Eng: David Hurdle		Paul, C. Buff Inc.	
PCB81878781		2725 Bransford Ave.	
<User Ext. #3>		Nashville, TN 37204	
<User Ext. #4>			
<User Ext. #5>			
Sheet Title:	Sheet File Name:	Sheet Number:	Sheet Date:
Radiorenote Receiver	RFRX.sch	8	10/28/81
Sheet Description:	Sheet Number:	Sheet Date:	Sheet Date:
11/04/1999	11/04/1999	11/04/1999	11/04/1999

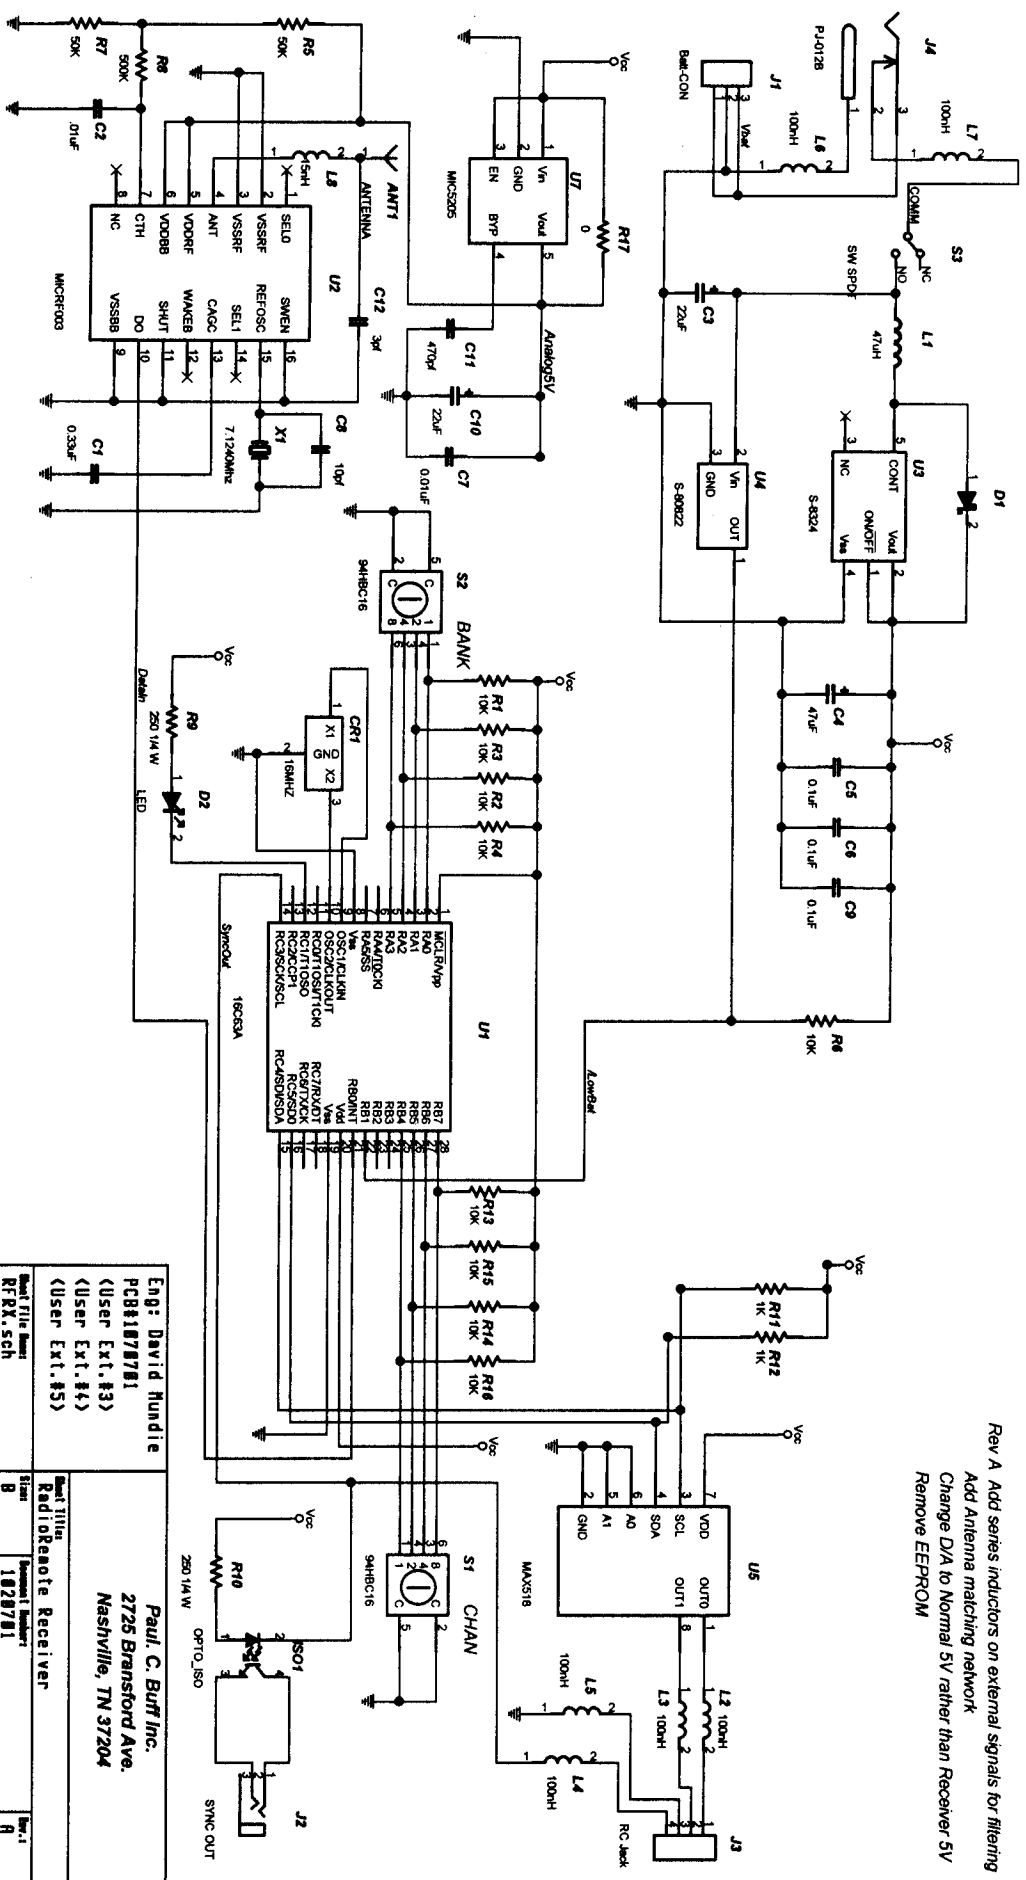
Rev A Add series inductors on external signals for filtering
 Add Antenna matching network
 Change D/A to Normal 5V rather than Receiver 5V
 Remove EEPROM
